Work Order ID 52154

Item ID: D209-669-014

Item Name: Skidtube RH

DART SERVICE INSTRUCTION
TO AMEND INSTALLATION INSTRUCTIONS IIN-D209-669 REV. B

5.0 PARTS LIST

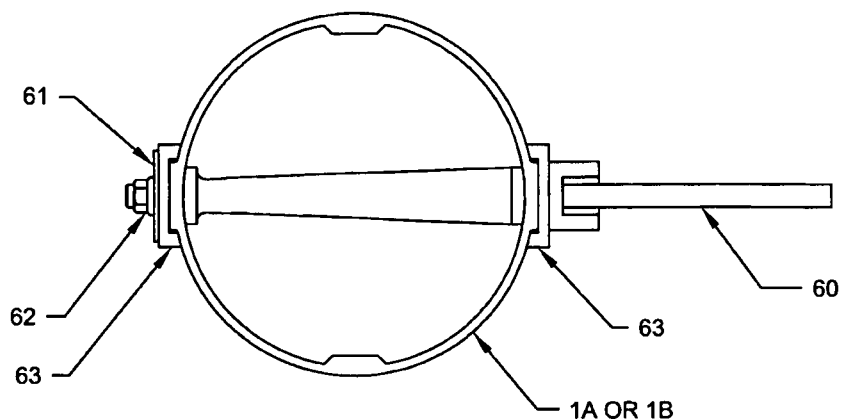
- a) REPLACE THE D2968-041 TOW RING WITH THE D3407-041 TOW RING ASSEMBLY.
- b) REPLACE THE D2736-1 AND D2736-3 GHW LUGS WITH THE D3405-041 AND D3405-043 LUG ASSEMBLIES.
- c) AMEND THE PARTS LIST IN SECTION 5.0 OF INSTALLATION INSTRUCTIONS IIN-D209-669 REV. B AS SHOWN ON PAGE 2 OF THIS DSI.

NOTE: ALL INSTALLATION FASTENERS FOR THE ABOVE CHANGES HAVE BEEN UPDATED. SEE THE AMENDED PARTS LIST ON PAGE 2 FOR DETAILS.

50	4	4	1	1			D3405-041	LUG ASSEMBLY
51	8	8	4	4			AN4C47A	BOLT
52	16	16	8	8			D2570	BUSHING
53	8	8	4	4			MS21043-4	NUT
54			1	1			D3405-043	LUG ASSEMBLY
60	1	1	1	1			D3407-041	TOW RING ASSEMBLY
61	1	1	1	1			D3456-1	WASHER
62	1	1	1	1			MS21043-4	NUT
63	2	2	2	2			D3417-5	WASHER

50	4	4	1	1			D2736-1	GHW LUG
51	8	8	4	4			AN4-46A	BOLT
52	16	16	8	8			D2570	BUSHING
53	8	8	4	4			MS21042L4	NUT (OR MS21042-4)
54			1	1			D2736-3	GHW LUG
60	1	1	1	1			D2968-041	TOW RING
61	1	1	1	1			AN970-4	WASHER
62	1	1	1	1			MS21042L4	NUT (OR MS21042-4)
